Re: Brighton Mill, Lot 6
Sewage Disposal Area setback variance request

LETTER OF TRANSMITTAL

Re: **General Waiver to waive to the ten (10) foot property line setback for sewage disposal areas in certain situations**

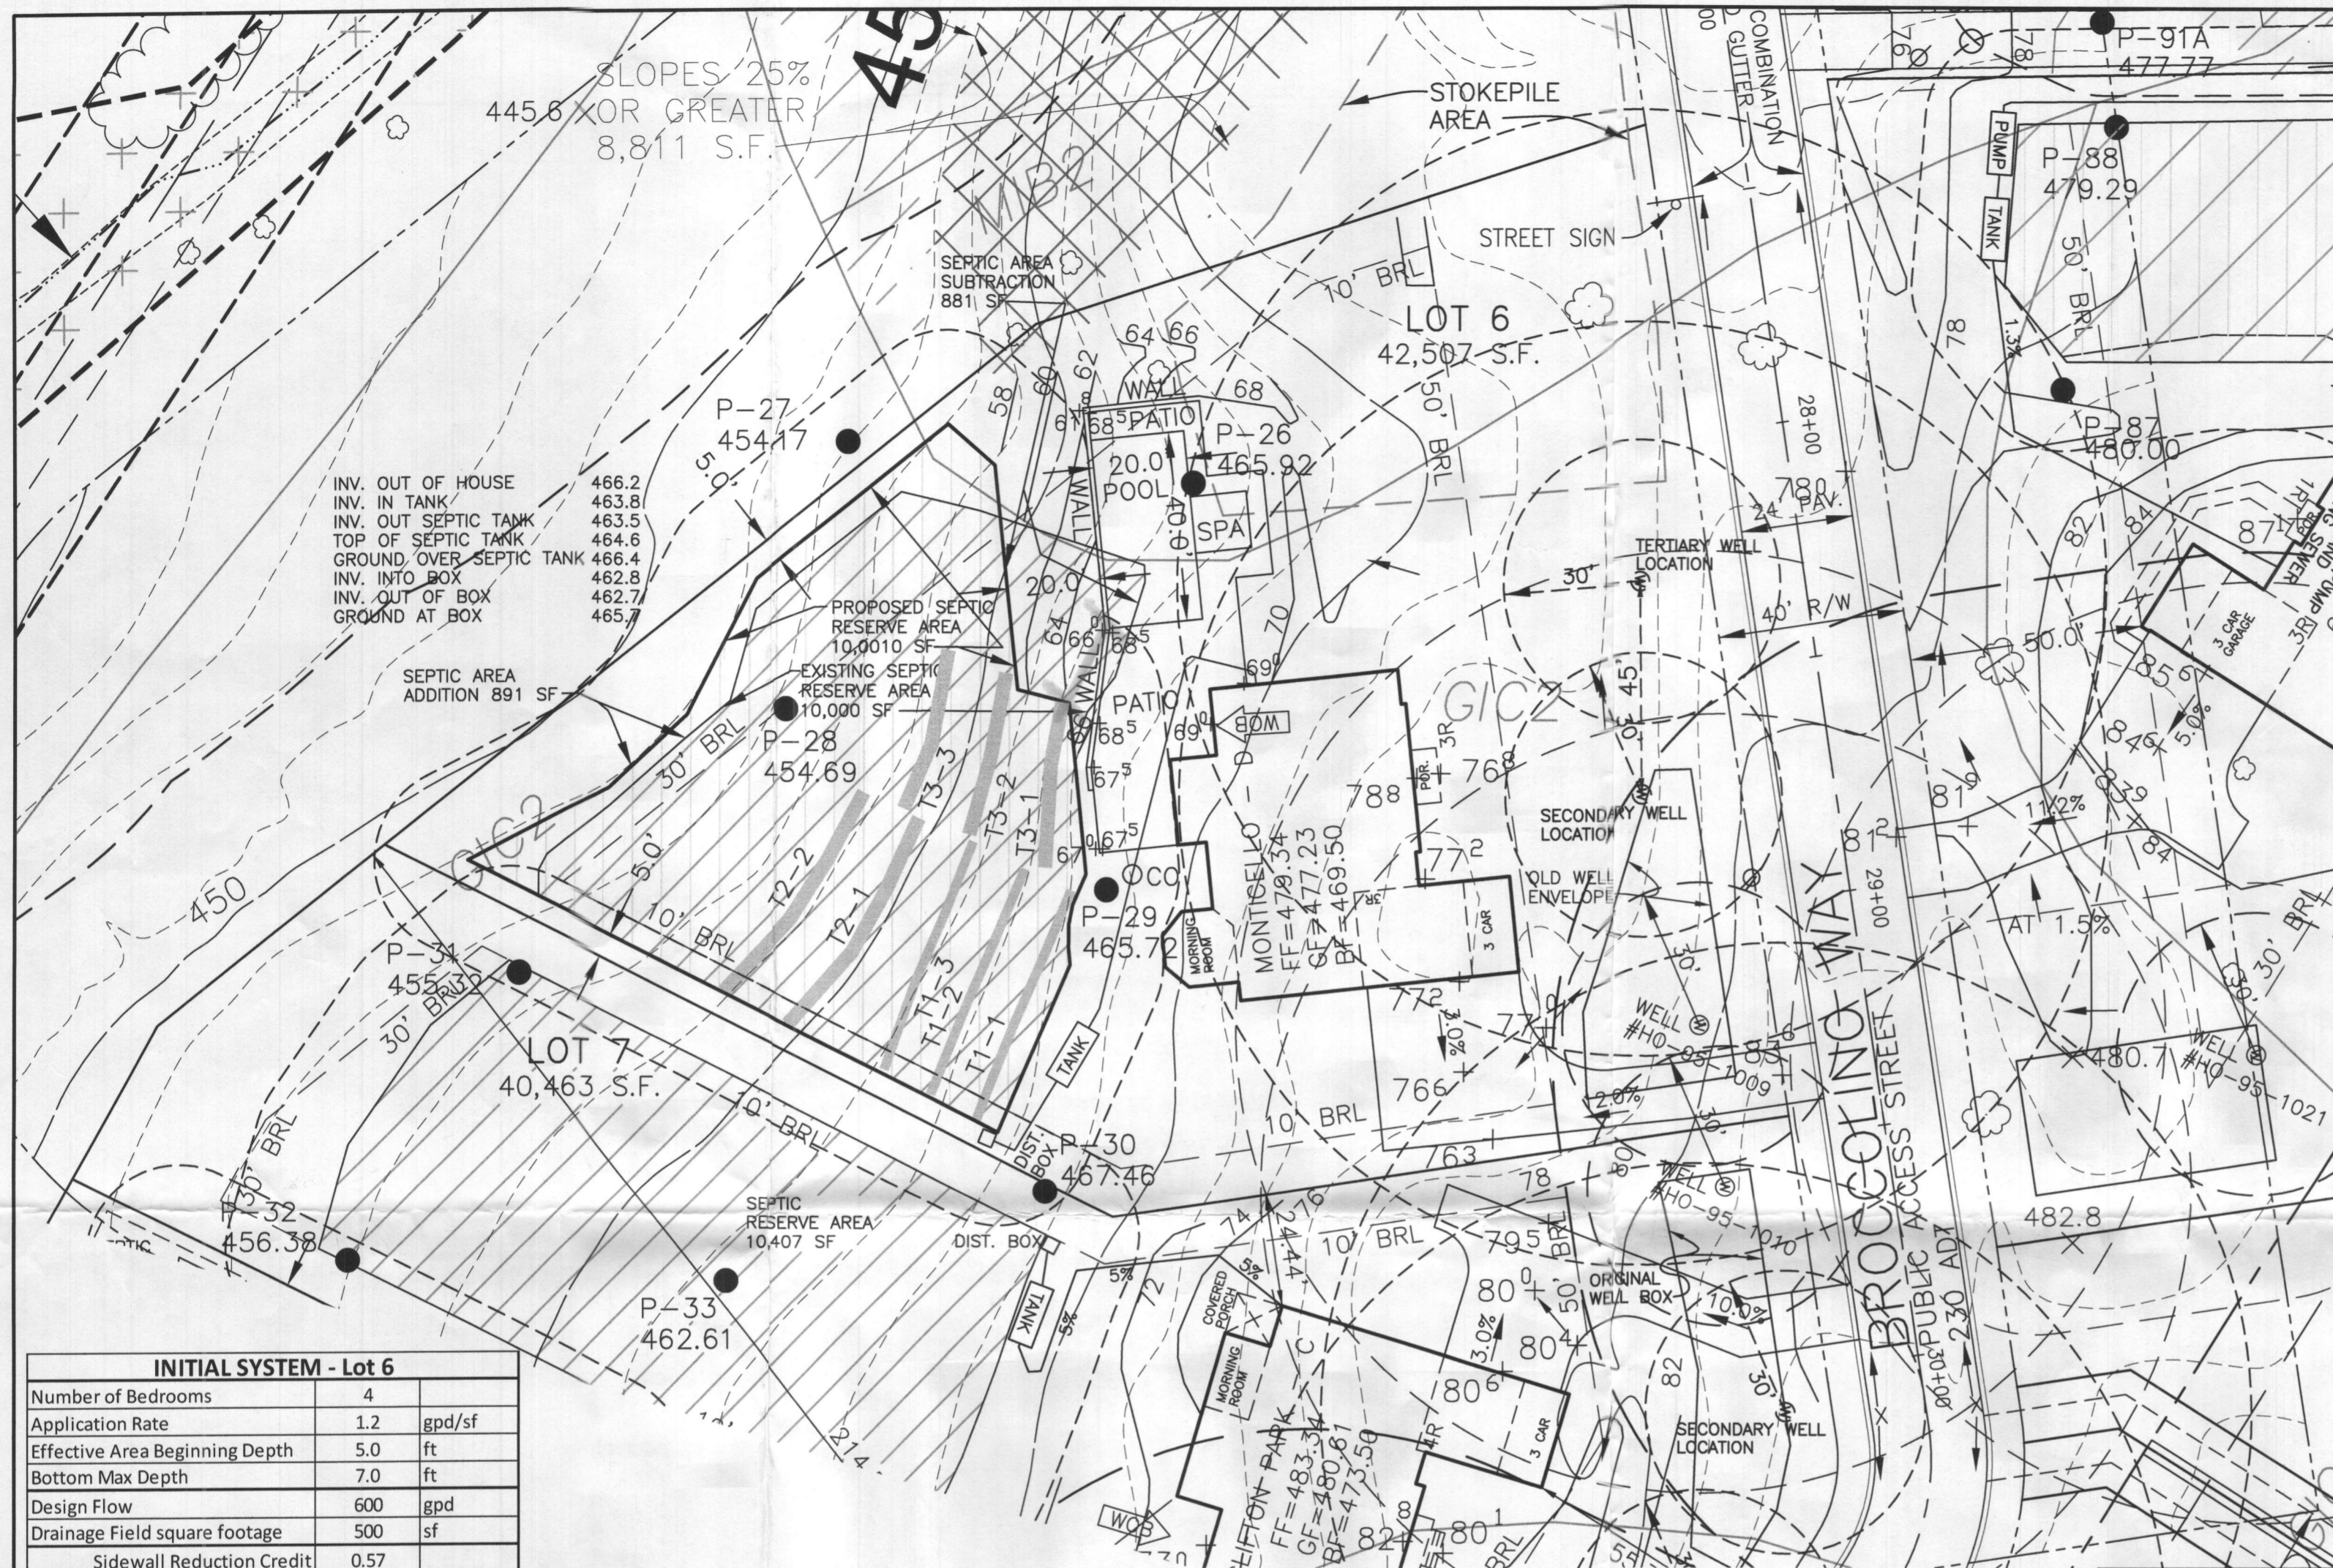
No waiver required from me unless I missed something. Waiver to steep slope (retaining wall) required from Steve. Not note on perc int.

I guess my concern with these would be where the drainage through these walls goes, but as long as that drainage is not directed too much over the septic area, tanks or system, I don't have an issue with them and I wouldn't say it needs a variance from us.

Hey Steve. I'm wondering how you want to handle issues related to retaining walls to SDAs in general and for this project attached. I've taken the stance that a large retaining wall should be setback 25' from an SDA under the interpretation that they are changing the grade and the wall is a steep slope. I have let up on that for very small retaining walls only a few feet high. In this case here, a retaining wall will be 7.5' high upgrade of an SDA 20' away. It slopes down to 2' high and will be as close as 4' away as it goes. I'm ok with it. I'm wondering if you think this sort of thing needs a variance request or what. Thanks

12. MDE has approved the retaining wall in its proposed location
